**WILLIAMS FARM: WREXHAM INDUSTRIAL ESTATE:  
REVIEW OF DRAINAGE MEASURES**

This is a Report on the existing solar park at William's Farm near Wrexham (LL13 0UT). Specifically, it describes the drainage measures that have been installed and on their suitability for compliance with accepted drainage design measures.

**Figure 1: Topography of Site**

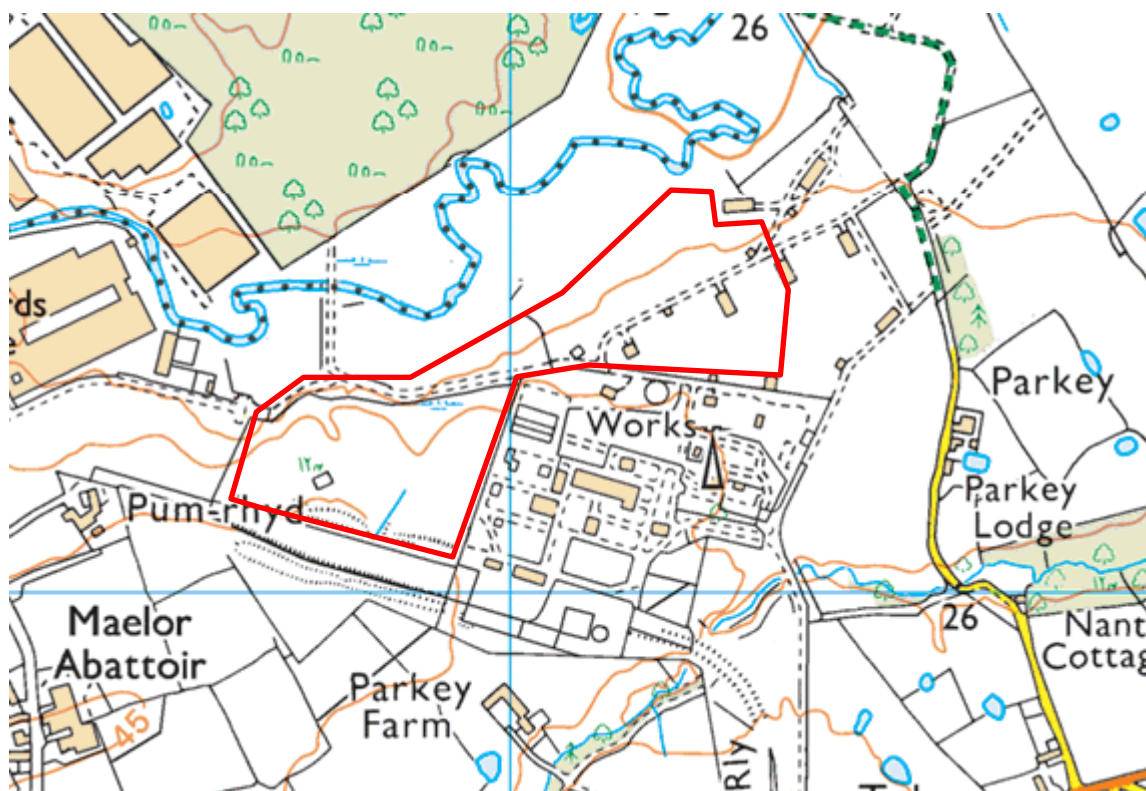
The topography of the Site is shown in Figure 1; this shows that the solar farm is located on northerly facing slopes that drain towards the River Clywedog. The contours show that the highest point on the southern boundary is at around 40 mAOD, whilst the lowest point on the north western boundary is between 20 and 25 mAOD.

Figure 2: Proposed drainage measures as per the SWMP

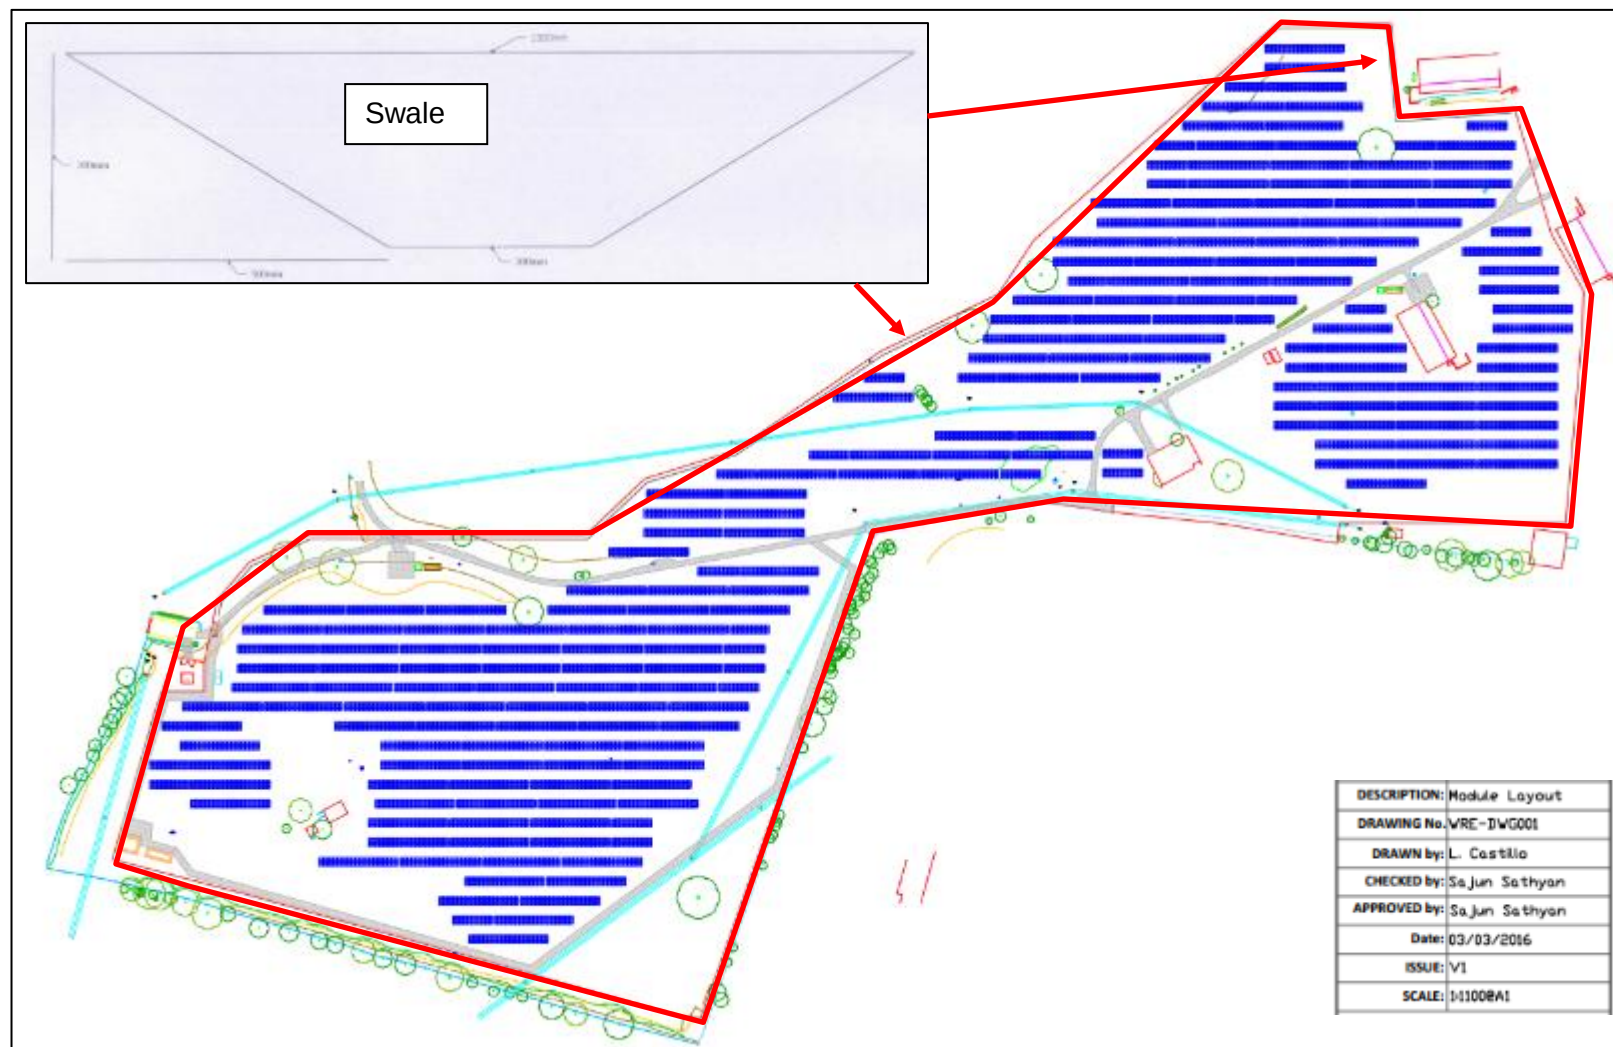
The drawing shows a series of swales along part of the Site boundary. Their combined length is given as 600 m in the report with nominal dimensions shown on the inset to Figure 2 and comprising bottom width of 300 mm, top width of 1300 mm and depth of 300 mm.

The basis for the sizing of swales is not clear from the Report. The swales provide 144 m<sup>3</sup> of storage which is greater than a calculated volumetric requirement of around 130 m<sup>3</sup>.

**Figure 4: Surface Water Flood Risk (NRW Web Site) with locations of waterlogging**

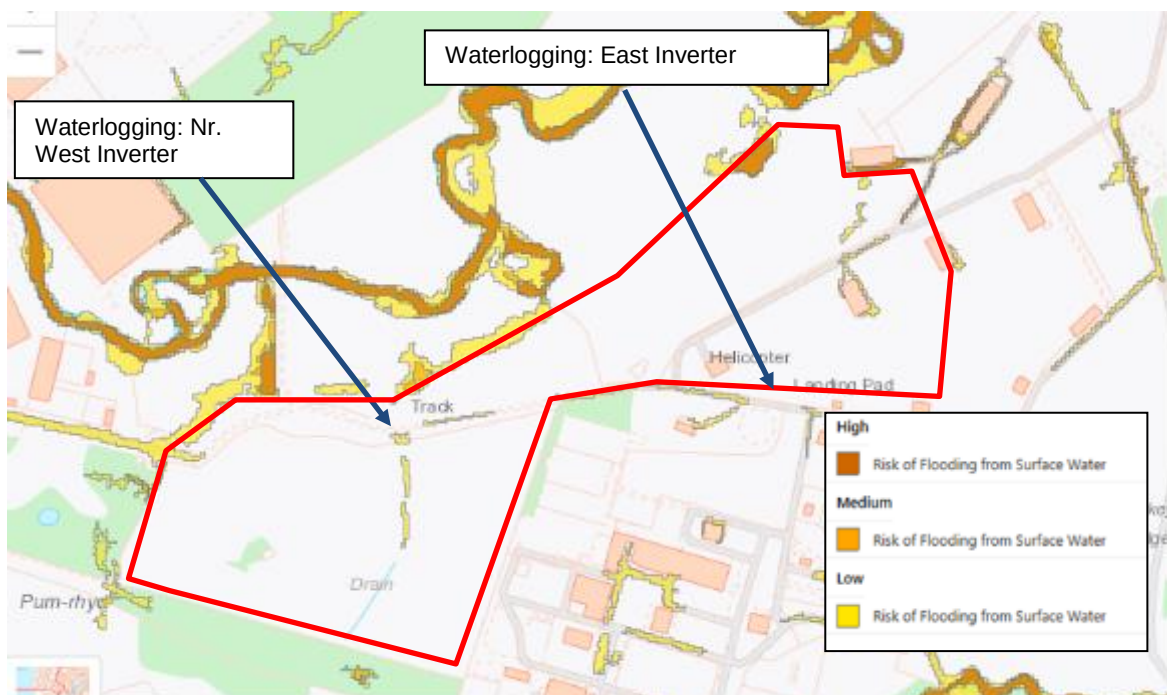
Extracts from the NRW (Natural Resources Wales) Web Site are given in Figure 3 for Fluvial Flood Risk and Figure 4 for Surface Water Flood Risk. This shows that the Site lies almost entirely within Fluvial Flood Zone 1, with an annual exceedance probability (AEP) of flooding of lower than 0.1% (very low category). There is minor encroachment into flood zones along the north western boundary, but this is of no practical consequence. The majority of the Site is at very low risk of surface water flooding being unshaded in Figure 4. The exception is a small area on the north western margin where there is a high risk.

The first of these is shown in Figure 7 where the topography converges on a shallow depression, just south of the access road that was wet at the time of the visit. The dry sediment on the road surface showed that at times, this area did spill to the north, but it was not doing so at the time of the visit. The land that feeds to this wet area was investigated and is shown in Figure 8. It also seems to suffer from intermittent waterlogging, likely due to soil texture and the shallow slope and the presence of a blue-line (marked as a drain) on Figure 4.

**Figure 5: Soil Properties (NSRI Soilscape Website) - approximate boundary shown in red**

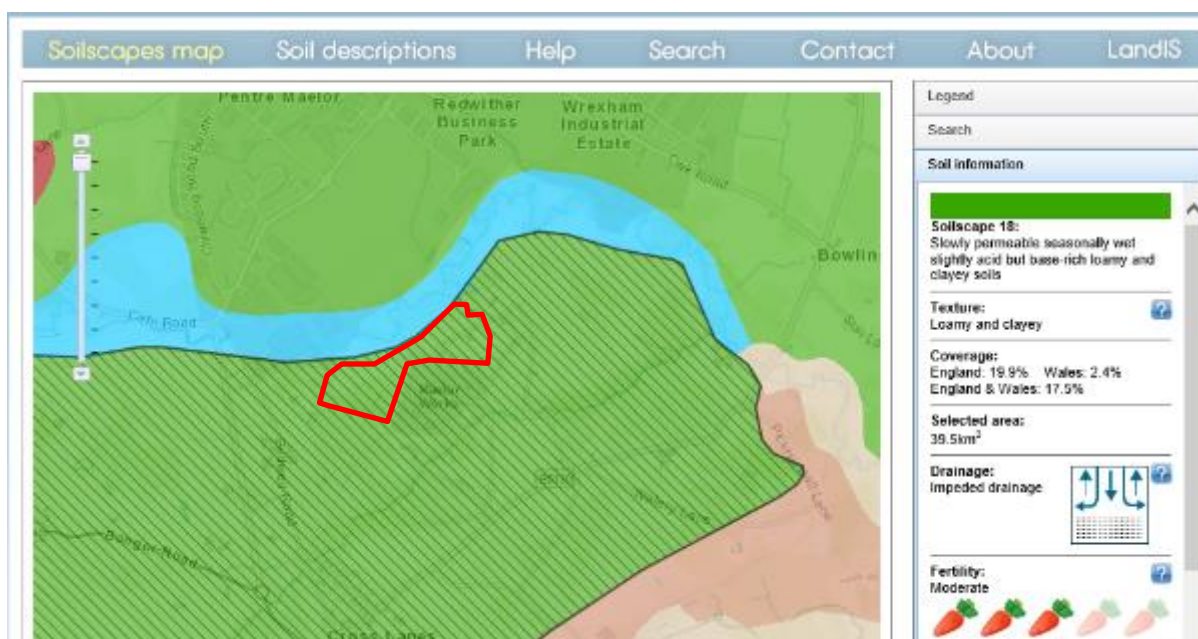
The soil properties for the Site are illustrated in Figure 5 from the NSRI Soilscape web site. This shows that the soils are “slowly permeable and seasonally wet”. This is relevant to the viability of swales since it gives a strong indication that infiltration swales would be unlikely to be an effective drainage measure. This consistent with infiltration testing that was reported in the SWMP.

**Figure 9: Area of waterlogging resulting from runoff onto the Site – south of Inverter set #2**

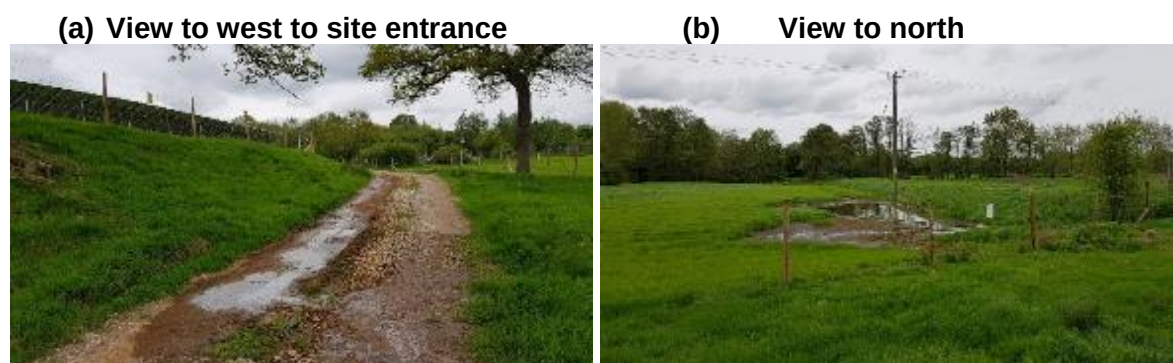
The second area of pronounced waterlogging was also on the southern boundary and south of the East inverter set. This is shown in Figure 9 and results from water entering the Site from the south. It appeared as if road surfaces were draining informally onto the William's Farm site. This is therefore an "inherited" drainage problem for which there seems little that can be done currently to avert it. It is posing no practical problems for the operation of the Site.

**Figure 12: Newt ponds**

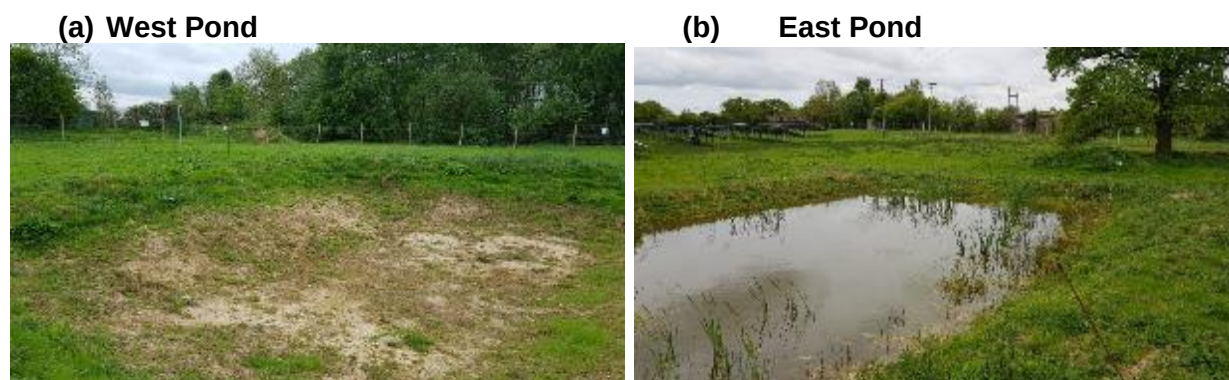
Two newt ponds had been constructed – one in each of the principal fields. The photos in Figure 12 show how the west pond was dry; this was hardly surprising given that there was no catchment draining to it and the texture of the bed was found to be silty/sandy and unlikely to hold water. The east pond was holding water, reflecting both a reasonable inflow and an ability to hold water.

**Figure 13: Labelling of site margins**

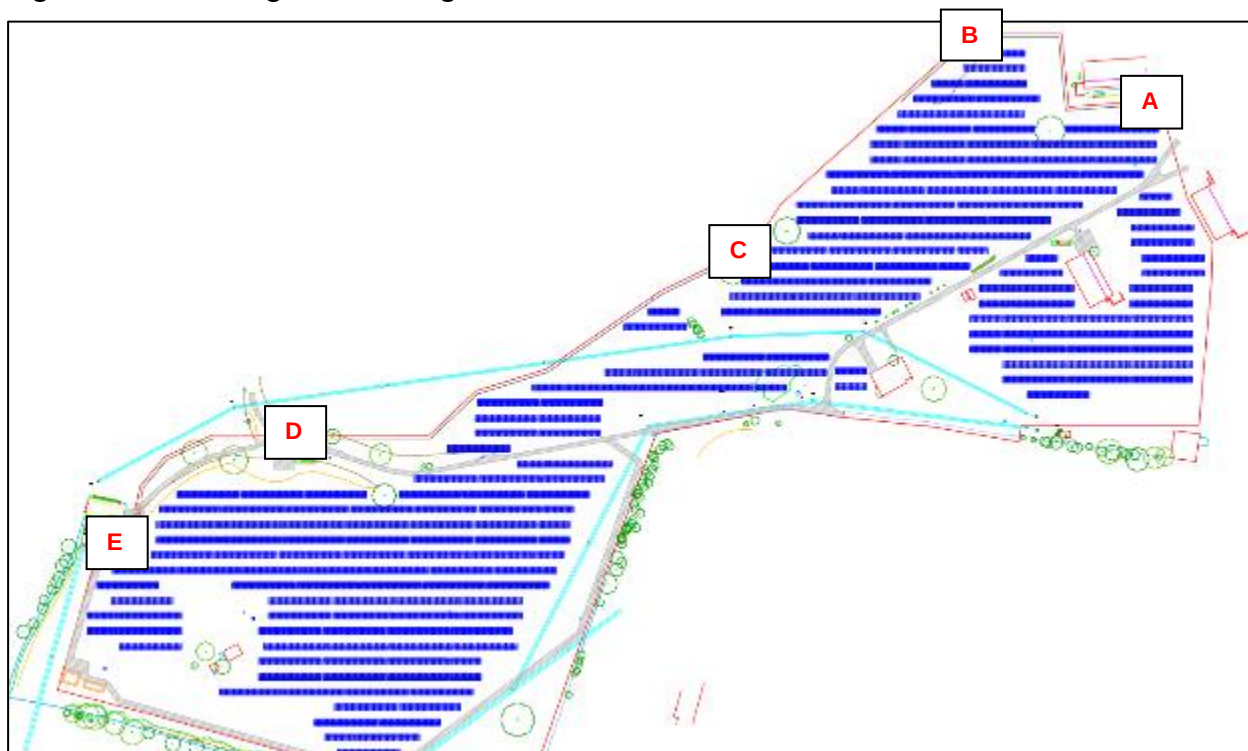
The referencing of the Site margins is shown in Figure 13.

**Figure 15: Part of Section BC**

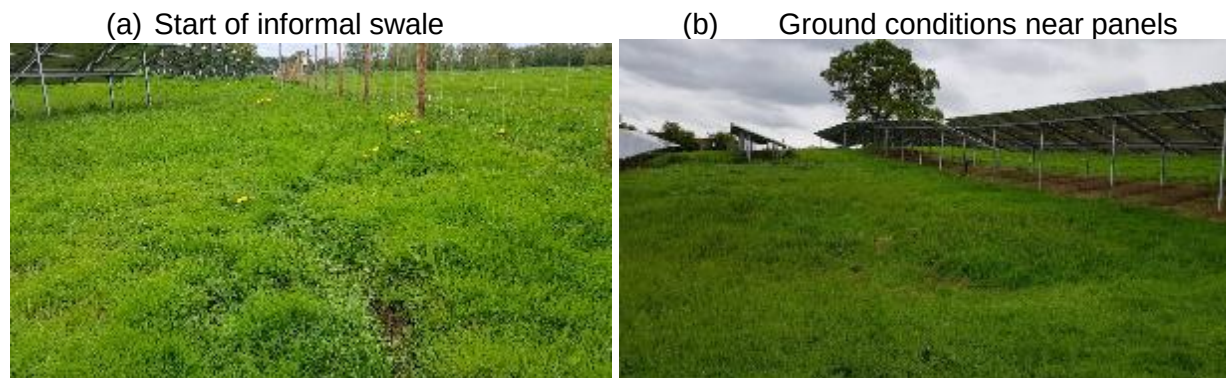
The SWMP proposed a swale for a short part of the Section BC. In practice, an informal swale exists along the entire length of BC (Figure 15a). It has a width of around 1 m and depth of up to

0.25 m. There was no indication of any waterlogging along its length. Similarly, there was no indication of excess runoff from the panels, even on the relatively steep slopes as shown in Figure 15b.

It was concluded that the informal swale, as constructed, provided a suitable buffer for any runoff that may drain from this part of the Site during an extreme storm. **No additional measures are required for this Section.**
